LAKE PONTCHARTRAIN, LA.
AND VICINITY
LAKE PONTCHARTRAIN
HIGH LEVEL PLAN

DESIGN MEMORANDUM NO. 17
GENERAL DESIGN

**JEFFERSON PARISH
LAKEFRONT LEVEE**

Lake Pontchartrain, La & Vic/High Level Plan
GDM No. 17A - Jefferson/St. Charles Return Levee-
2nd End.

JEFFERSON / ST CHARLES PARISH
RETURN LEVEE - I WALL
NET LEVEE EL 6.0
B/L STA 197+38 TO STA 231+20

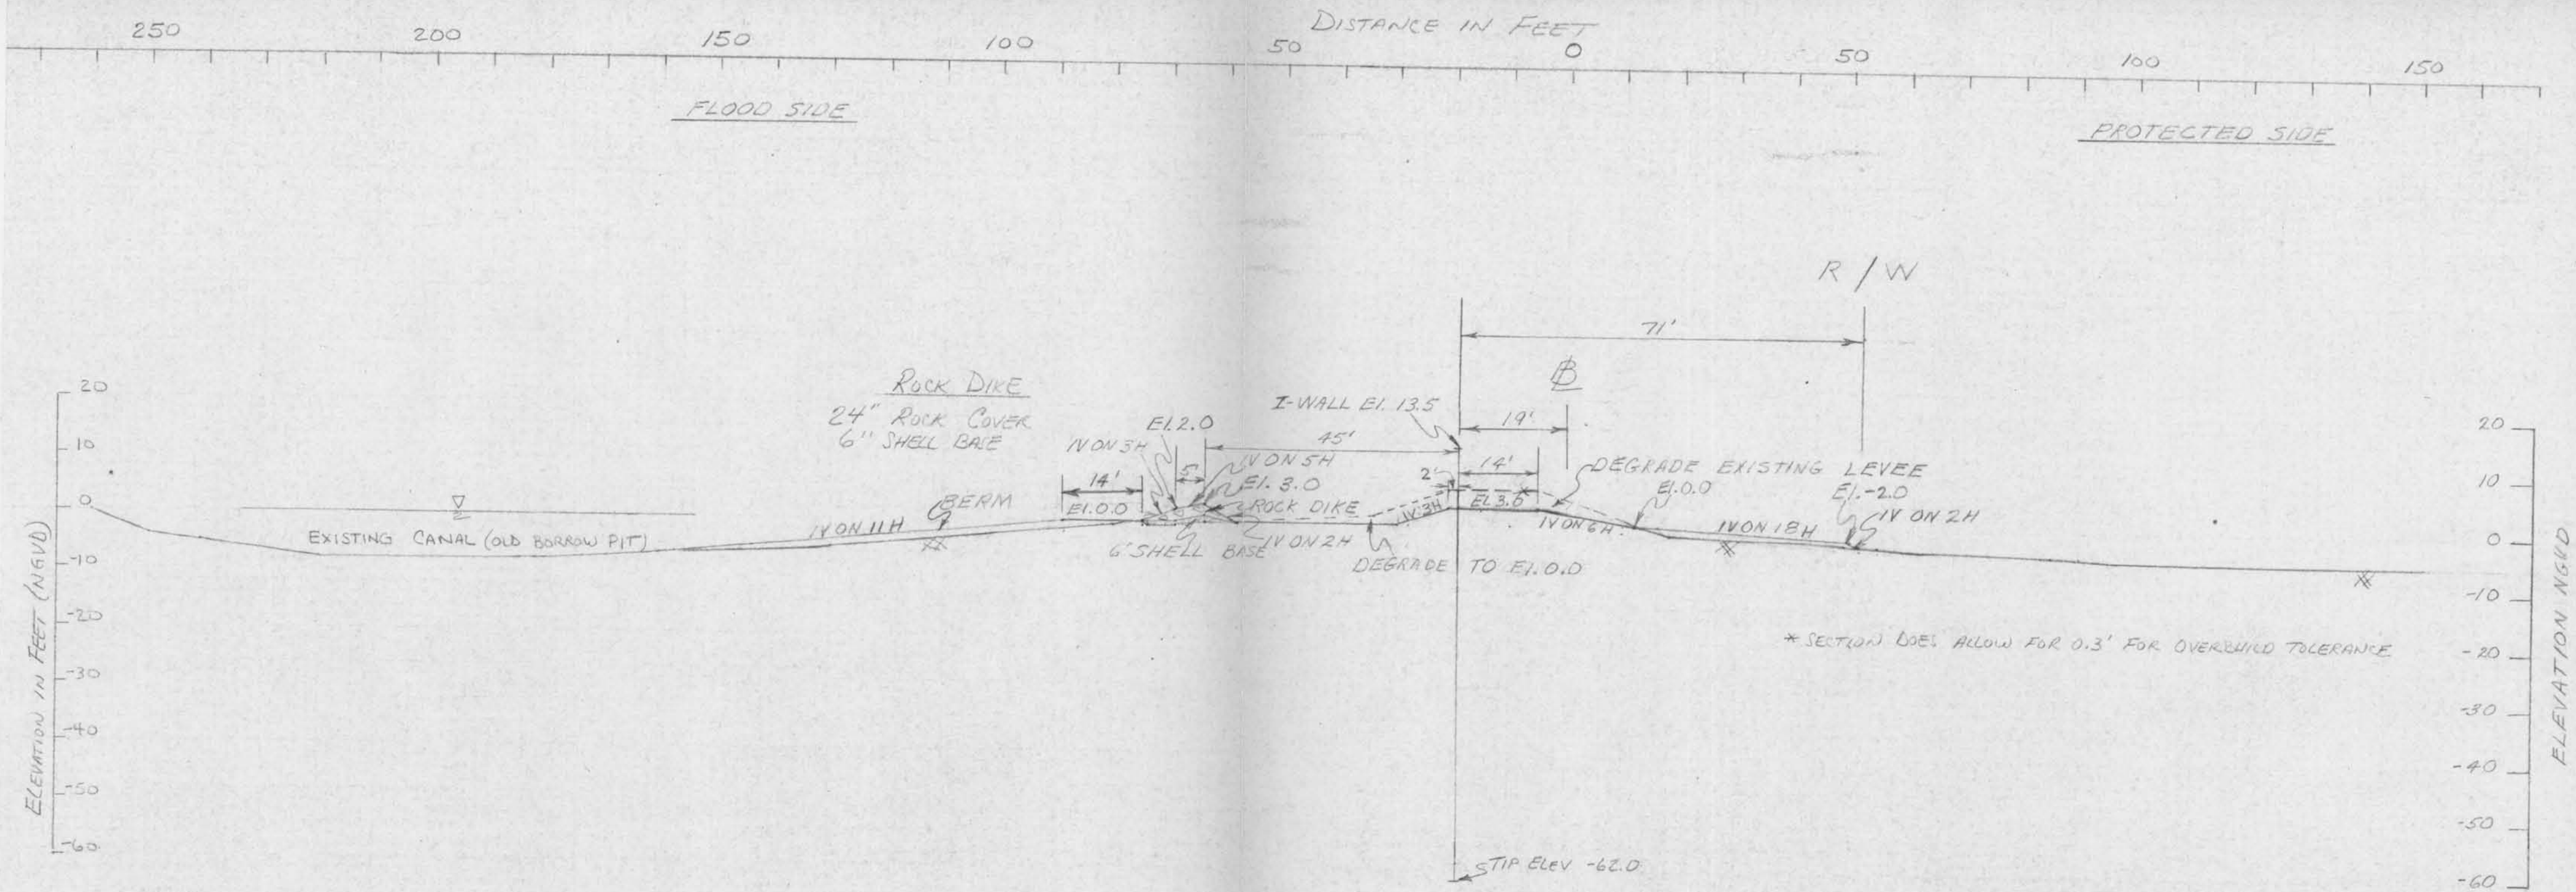
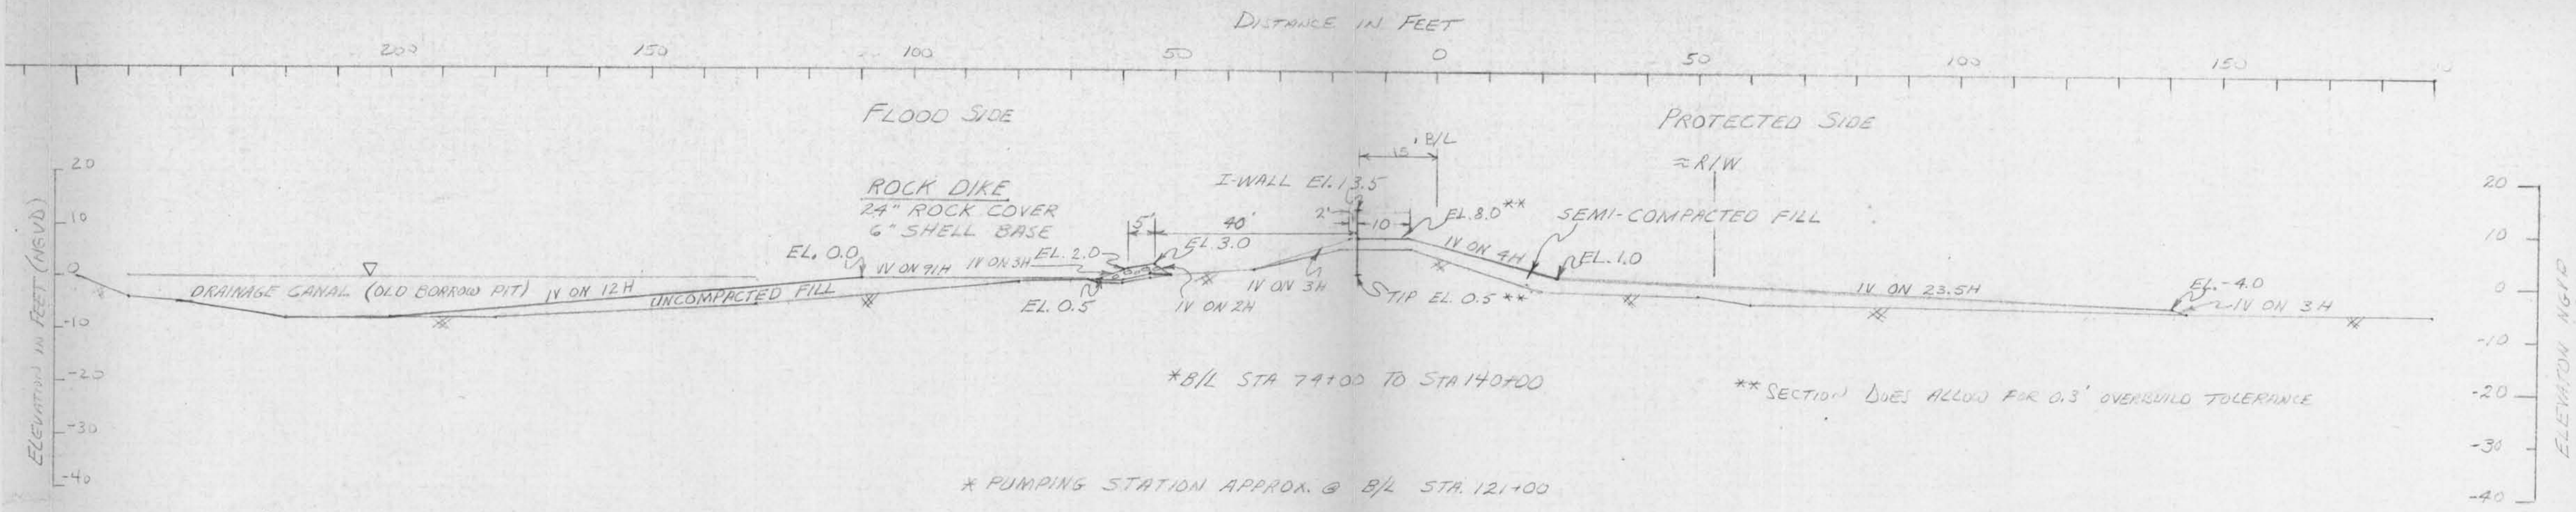
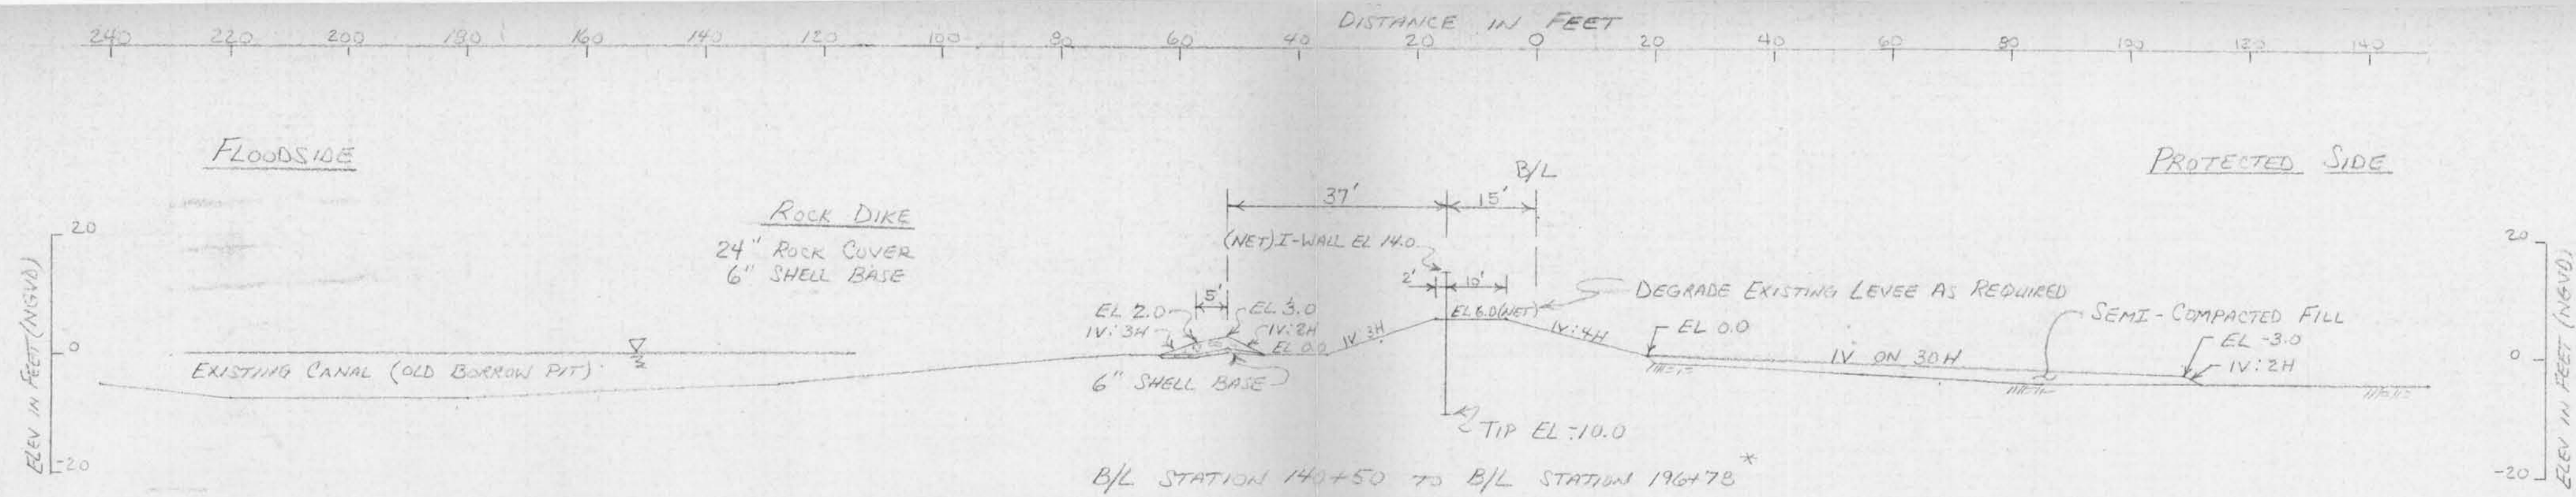
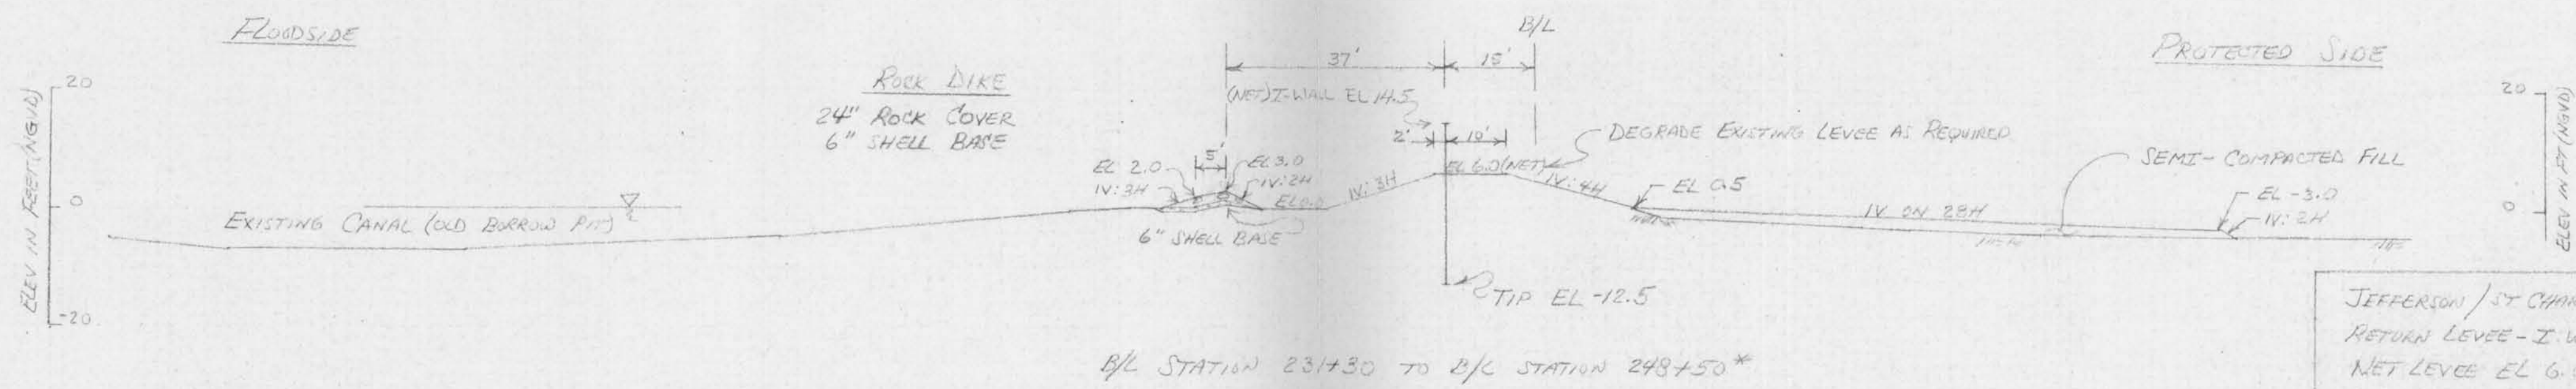
d. Plates 18 and 19. The proposed I-wall alternative design shown on these plates consists of degrading the existing levee, filling the adjacent canal with uncompacted fill, relocating the canal, and constructing a levee/I-wall on the uncompacted fill. This alternative is obviously prohibitively expensive, and in addition, construction would be difficult. The most desirable and economical I-wall design would be to degrade the existing levee to the maximum extent possible, construct an I-wall near the existing sheetpile alignment, and add protected side stability berms as necessary. We understand that this design alternative was not pursued since protected side rights-of-way constraints precluded berm construction. In order to determine the least costly alternative you should perform the structural and stability analyses for the I-wall constructed on the existing levee crown with a protected side berm. The cost for this alternative, including rights-of-way, should be compared with the proposed T-wall design on a reach by reach basis.

d. Plates 18 and 19. Concur. We have reexamined the I-wall in levee alternative to determine the most cost effective I-wall plan. The minimum degraded levee elevation that could be made to satisfy both foundation and structural stability requirements was determined for the levee reach addressed in this GDM. For the purpose of developing a cost estimate, where existing structures preclude construction of a protected side stability berm, the proposed method of protection would be T-wall construction. In these areas, the costs for acquisition of lands and relocations would obviously be cost prohibitive. In addition to the I-wall alternative with minimum levee height, several other I-wall in levee plans having higher crest elevations were checked to determine if the cost for landside berm and real estate would outweigh any reduction in sheet pile cost. The following tabulation gives a comparison of estimated costs for the most cost-effective I-wall in levee plan along with the corresponding estimated cost for the optimum T-wall, GDM plan.

Based on the forgoing, it is recommended that only the subreach from station 198+00 B/L to station 213+50 B/L be protected by I-wall construction. The comparison of cost for the two types of walls between station 198+00 B/L and station 247+20 B/L shows that both plans would cost approximately the same, with the T-wall being about 2 percent greater in cost than the I-wall in levee with crown elevation of +6 NGVD. We feel that the difference in costs falls well within the allowable error of estimate. The adjacent protected side lands with this reach constitute prime real estate which is slated for medium to high-cost residential development. Many of the properties impacted by the I-wall plan would preclude any construction on the remaining part of the property not taken by the project. Not only would this be an extremely unpopular plan with the land owners but also would adversely affect the future tax base for the Parish and City of Kenner, LA.
